CERTIFICATE OF APPROPRIATENESS

Property: 2110 Kane Street, Lot 4, Block 406, BAKER W R NSBB Subdivision. The property includes a historic 1,989 square foot, one-story wood frame single-family residence situated on a 5,000 square foot (50' x 100') interior lot.

Proposal: New Construction – Garage apartment

Recommendation: Deferral

EAST SIDE ELEVATION

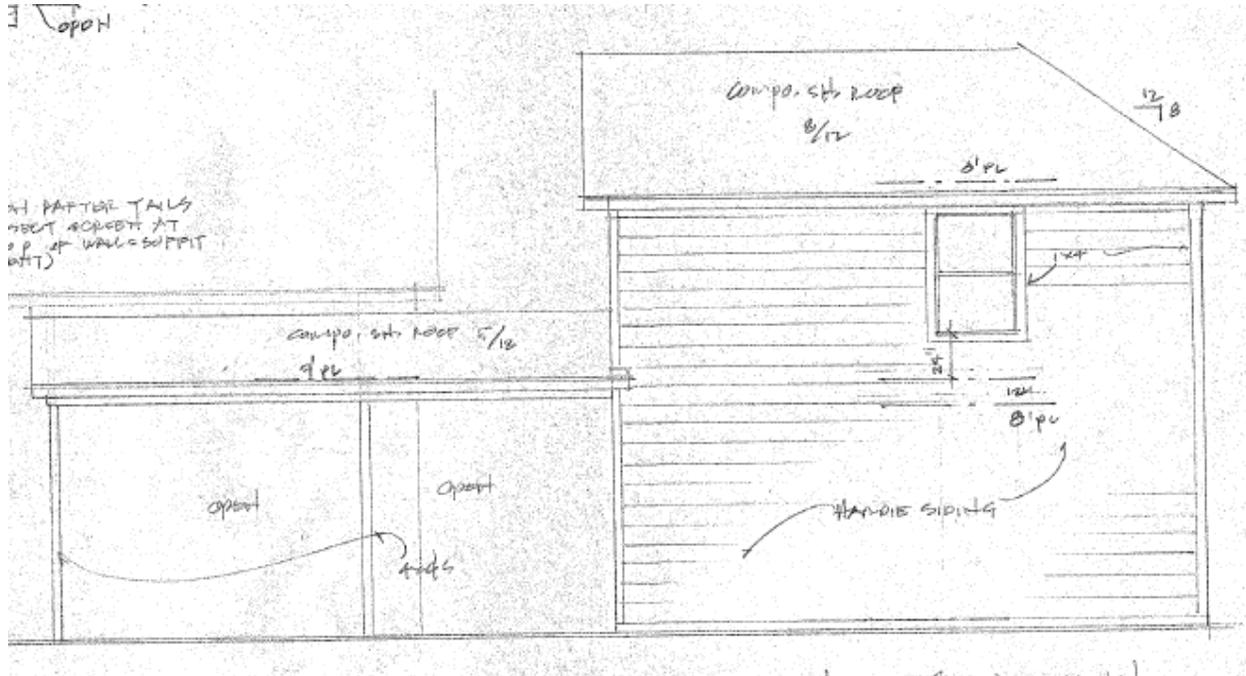
This design features several horizontally-proportioned windows, inappropriate for the neighborhood and not consistent with guidelines 3.a on page 34.
